Team #6

Design Reviews

Reviewed by Team 7: Jack and Edward Sunday November 16, 2025

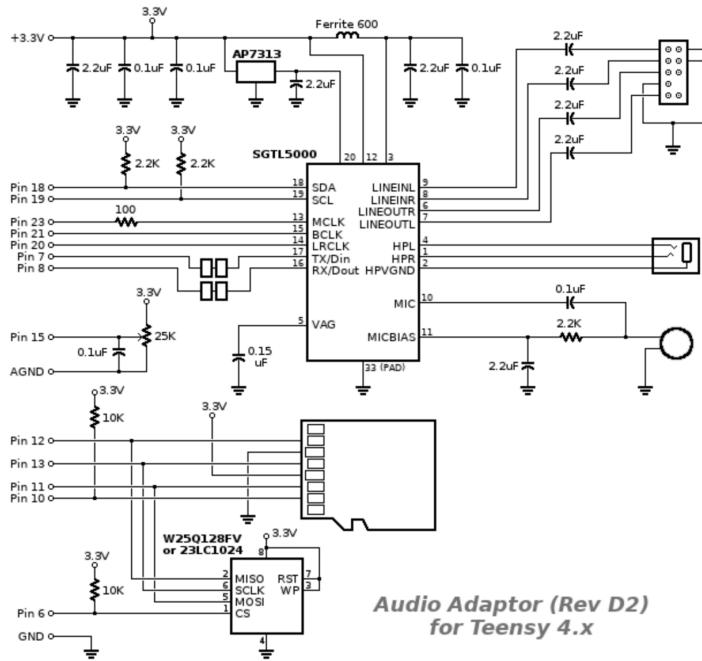
- Since it is only 1 page connect pins with wires instead of net labels
- Use labels for GND and 3v3 rails
- Make sure you hit SMD requirement for grade
- Rotary encoders examples should use a pull up resistor. They have them on the module
- GPIO's look like they are receiving the right thingies

Does the audio shield have a blocking capacitor?

What schematic revision are you using for the audio shield?

Rotary encoders are you planning on using the “click”?

Toggle switches are you using internal pull up resistors in your code

Can you plug in USB to boards to make sure they are the correct height?

- Yes on line in and out there are 2.2 uF caps

Schematic, Rev D2

- The click needs resistors or something to pull the up. Planning on changing the toggle switches to rotary encoder clicks. Will use internal pull-ups in the code

- YES? Code uses internal pull up for toggles

- Yes. Board will be above the PCB enough to plug in.
